Groundwater Transfer Review Summary Form

Transfer/PA # T- 14437 JH Enterprises (RA)

Ground Water Review Form:

Application: T-14437

Well Location Map

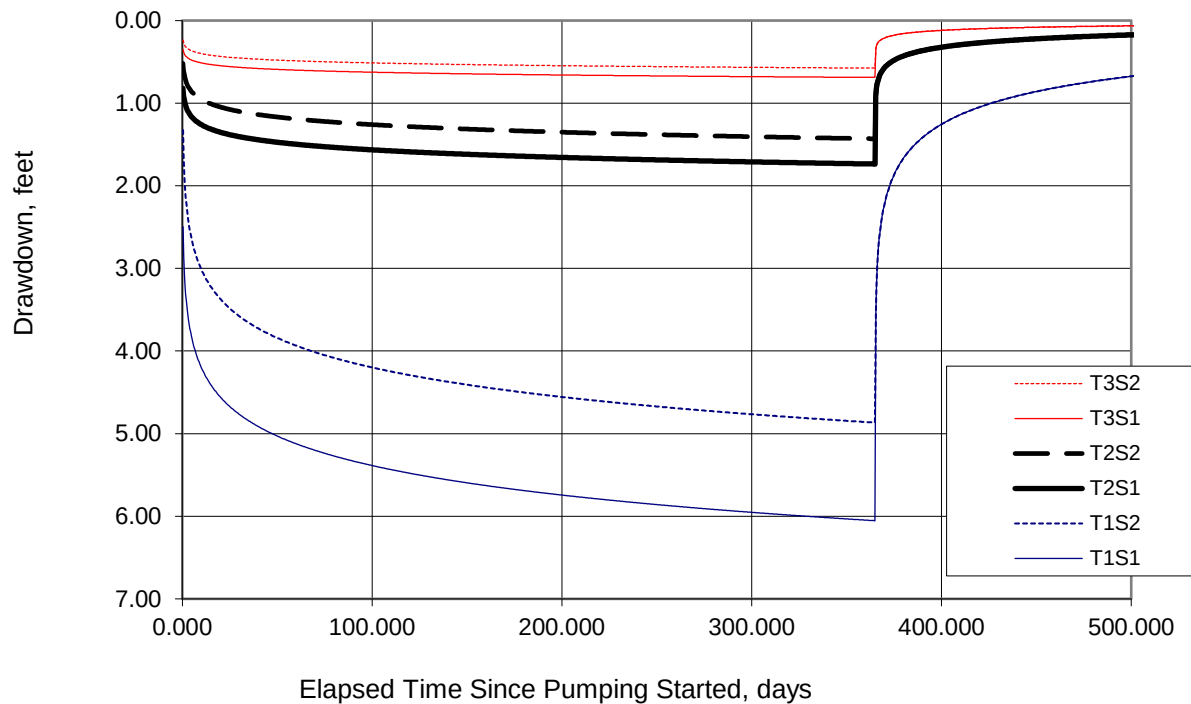
4. a) Will this proposed change, at its maximum allowed rate of use, likely result in an increase in interference with **another ground water right**?
☒ Yes ☐ No Comments: The proposed APOA is closer than the authorized POA to neighboring well MARI 8430, which is in the same aquifer as the POA and APOA. The closer proximity will likely increase interference with MARI 8430, which is an authorized POA for Permit G-10602.
